Re: Del Webb Amenity Center
9100 Del Webb Ln
Request Permanent C.O. - Approved
Engineer's Stamp dated: 7-18-15 (H09D0171C)
Certification dated: 7-14-16

Re: Grading and Drainage Certification – Final Certificate of Occupancy
Del Webb Amenity Center (H-9)

Re: Del Webb @ Mirehaven Phase I, Amenity Center Grading Plan, N-2-A of the Watershed Subdivision Engineer's Stamp Date 7/18/2015 (H09/D017C1)

Re: Del Webb @ Mirehaven Phase I
N-2-A of the Watershed Subdivision
Conceptual Grading & Drainage Plan (H09D017C1)

A-1

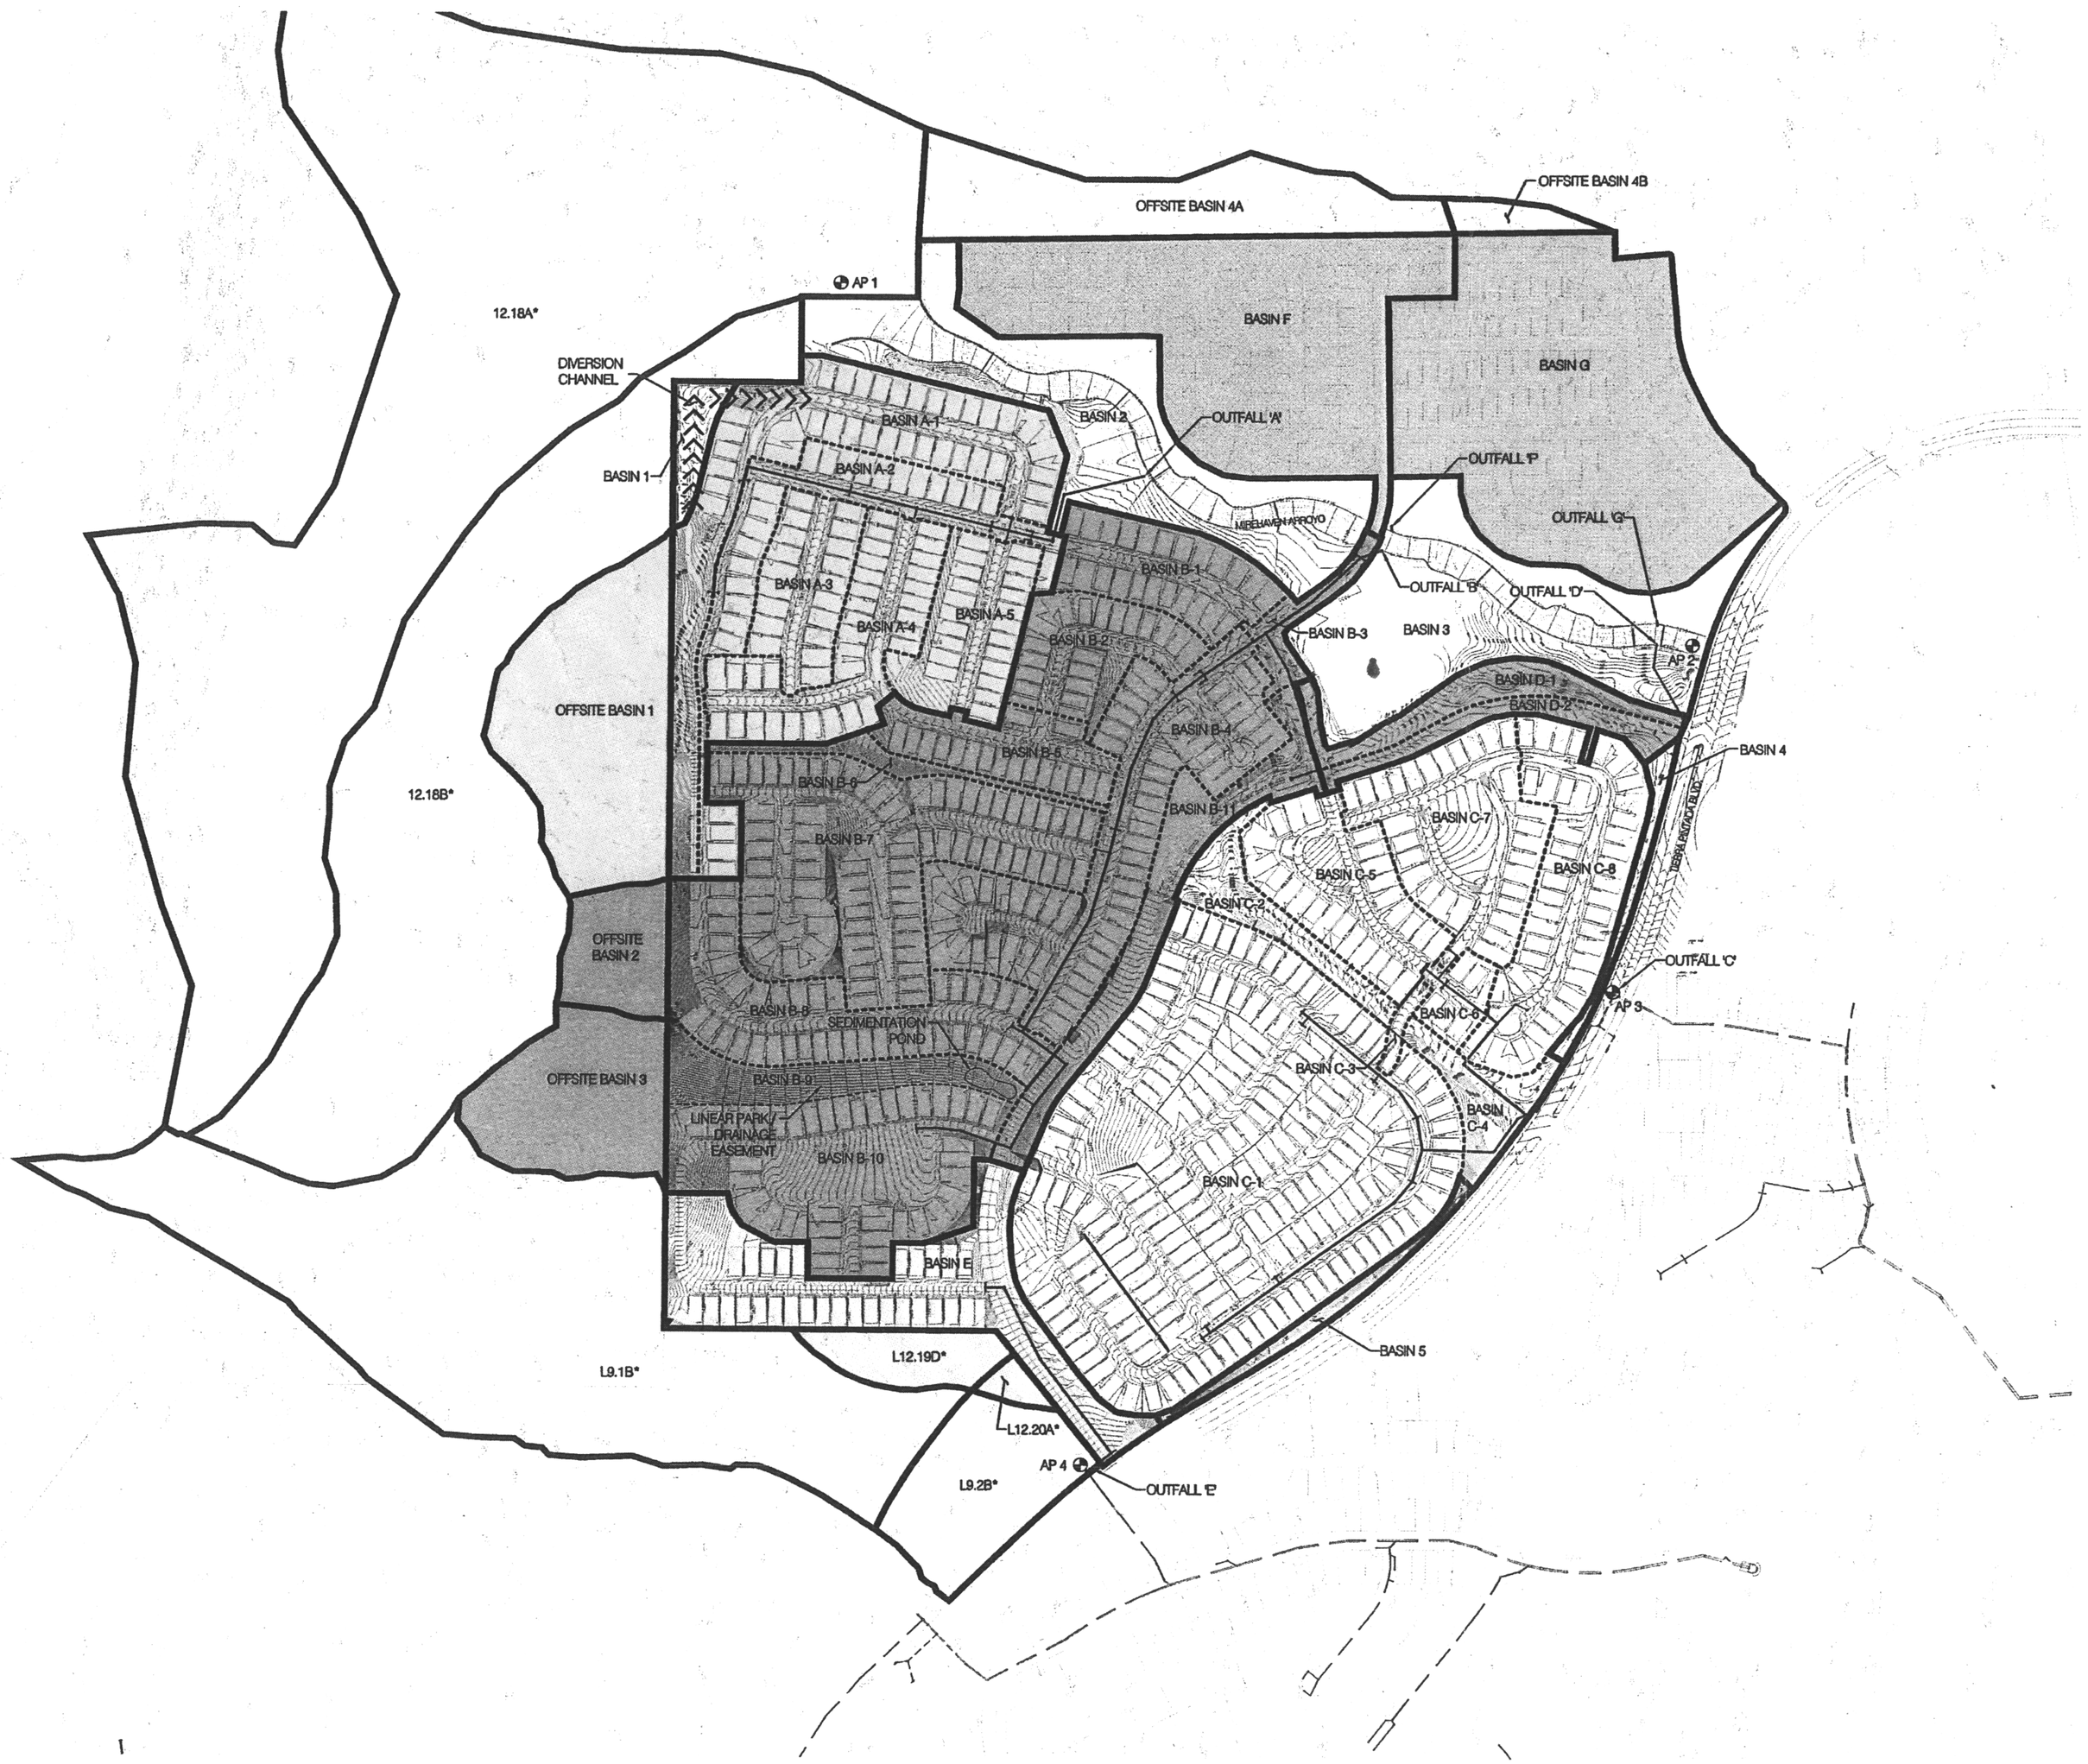
2. Show the capacity of the downstream inlets in Mirehaven Blvd and Tierra Pintada due to the additional 3.15cfs from the Amenity Center Site.

A-2

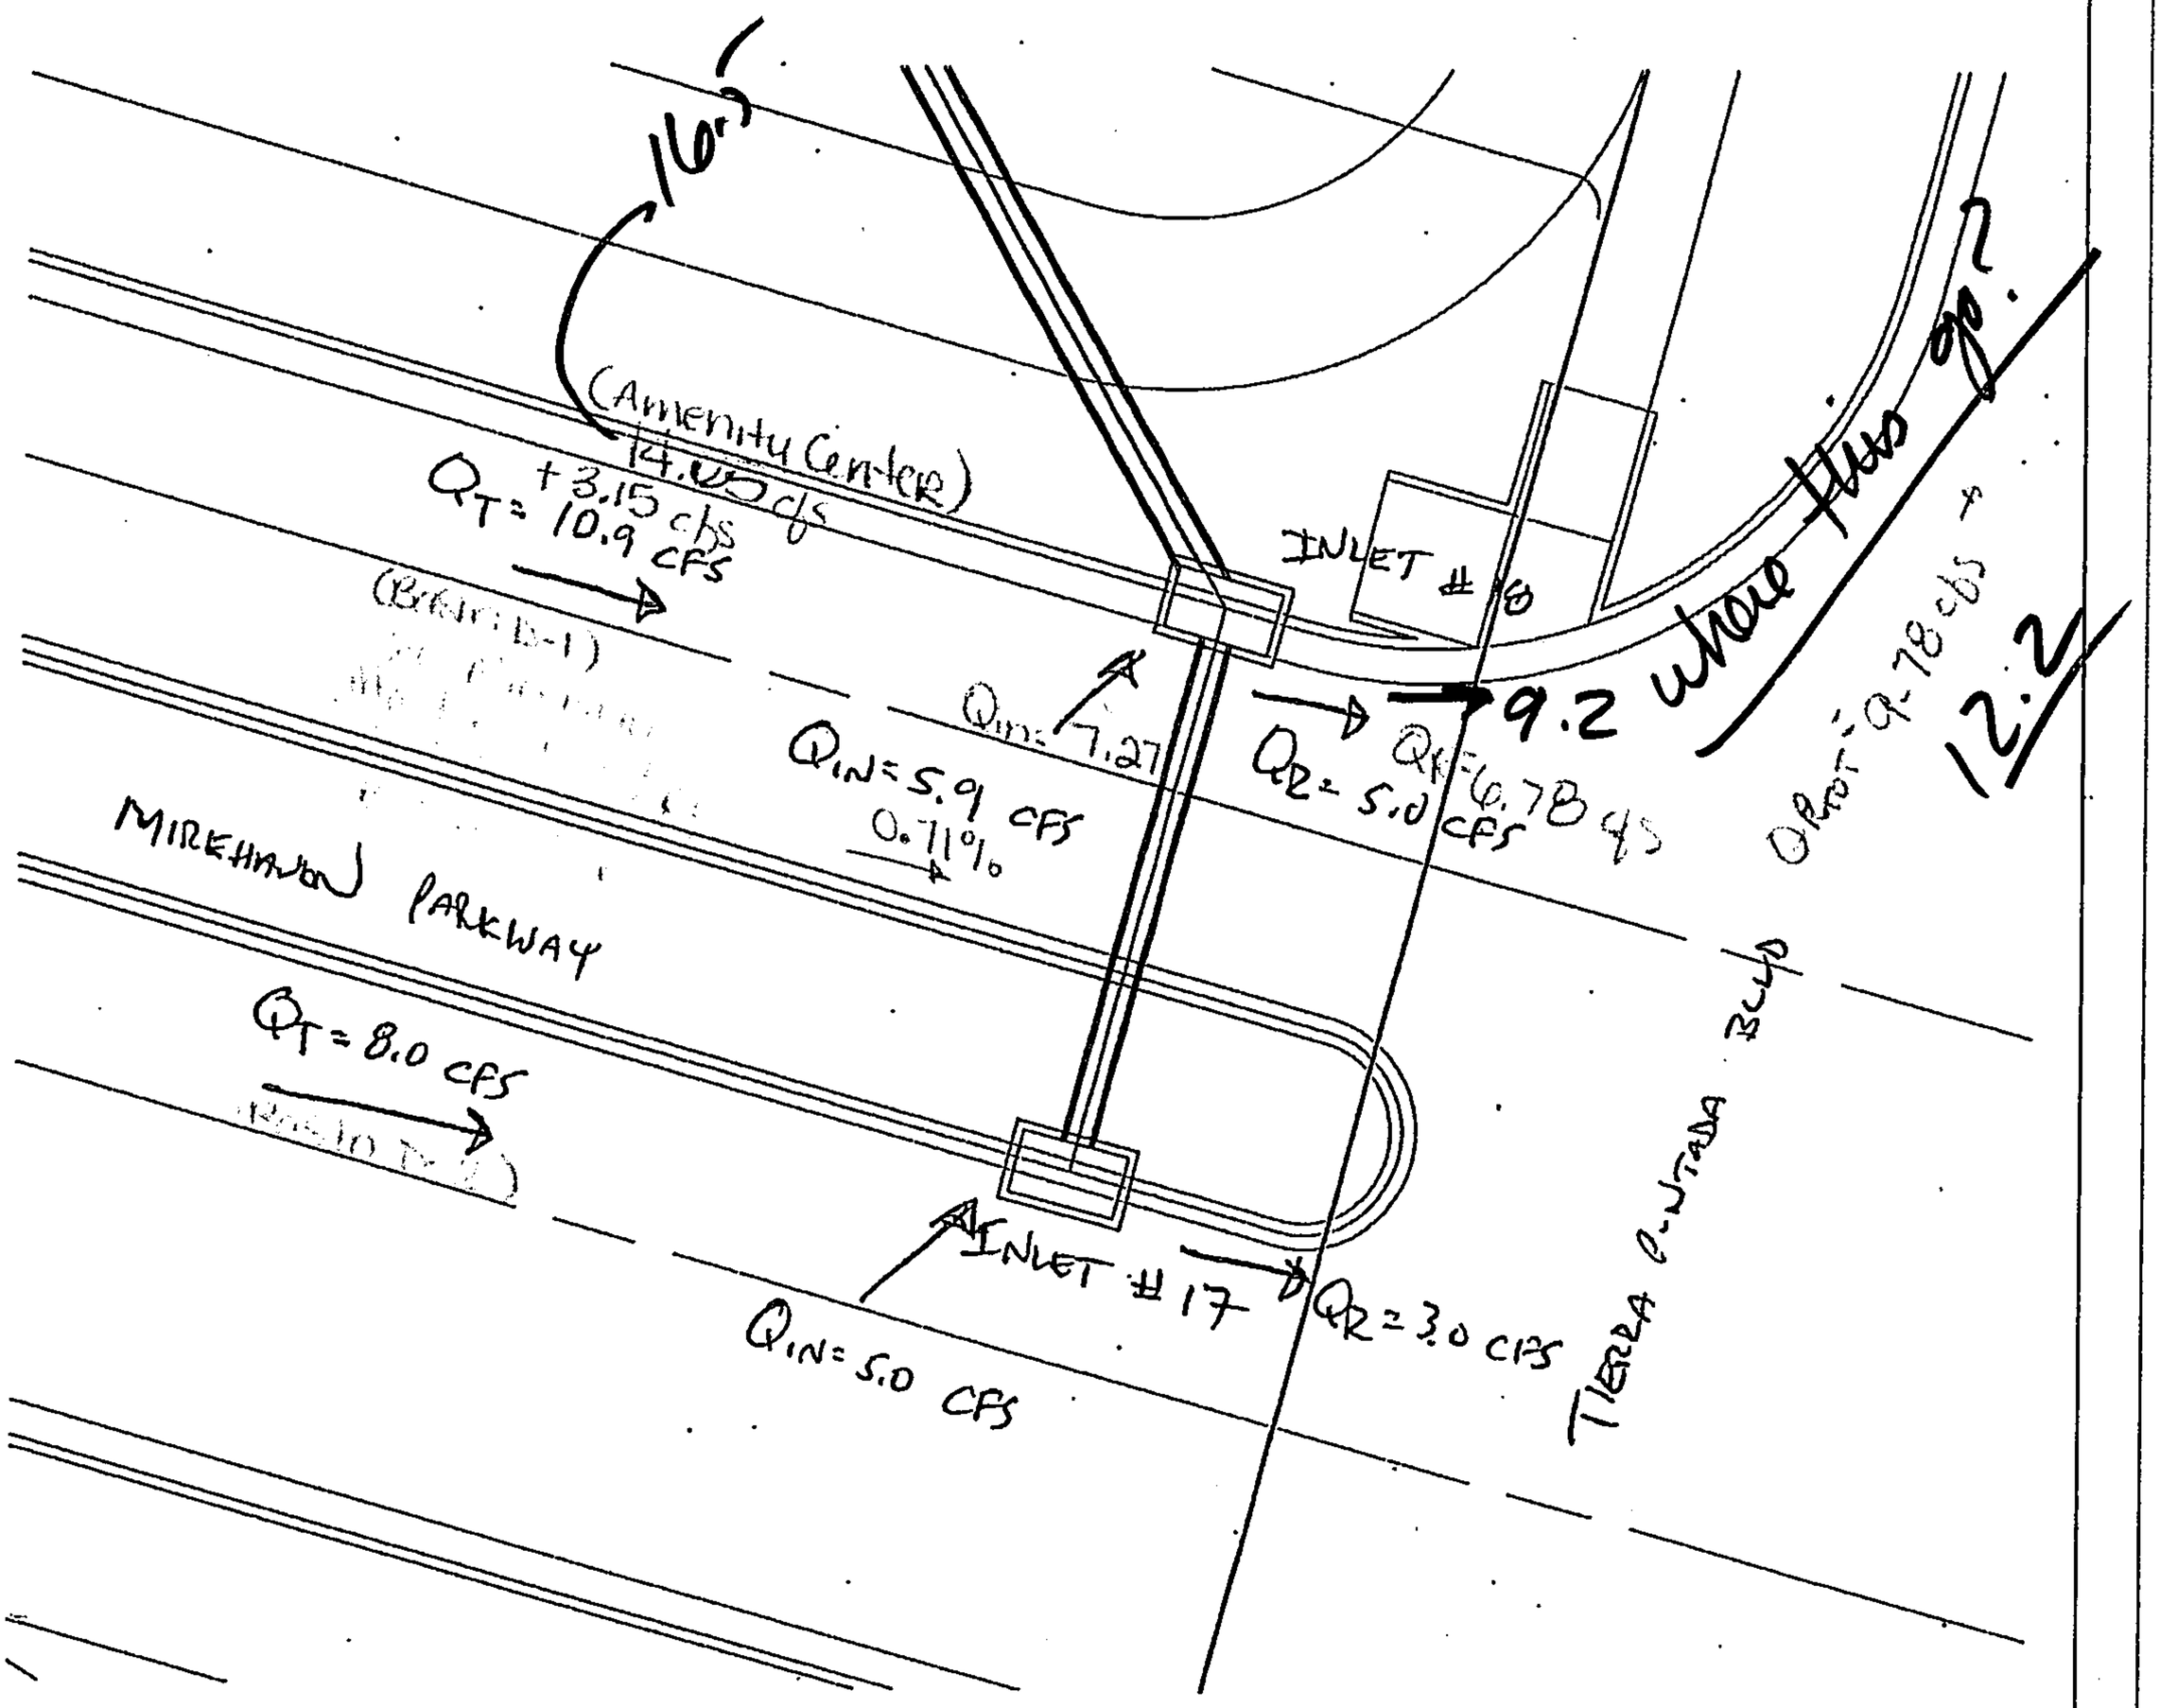
16.5
(Amenity Center)
14.05 cfs
+3.15 cfs
Q_T = 10.9 CFS
INLET # 18
9.2 where this go?
12.2
Q_{IN} = 7.27
Q_R = 6.78 cfs
Q_R = 5.0 CFS
Q_{IN} = 5.9 CFS
0.71%
Q_{tot} = 9.78 cfs
MIRENAUN PARKWAY
Q_T = 8.0 CFS
INLET # 17
Q_R = 3.0 CFS
Q_{IN} = 5.0 CFS
TIERRA ALTADA BLVD
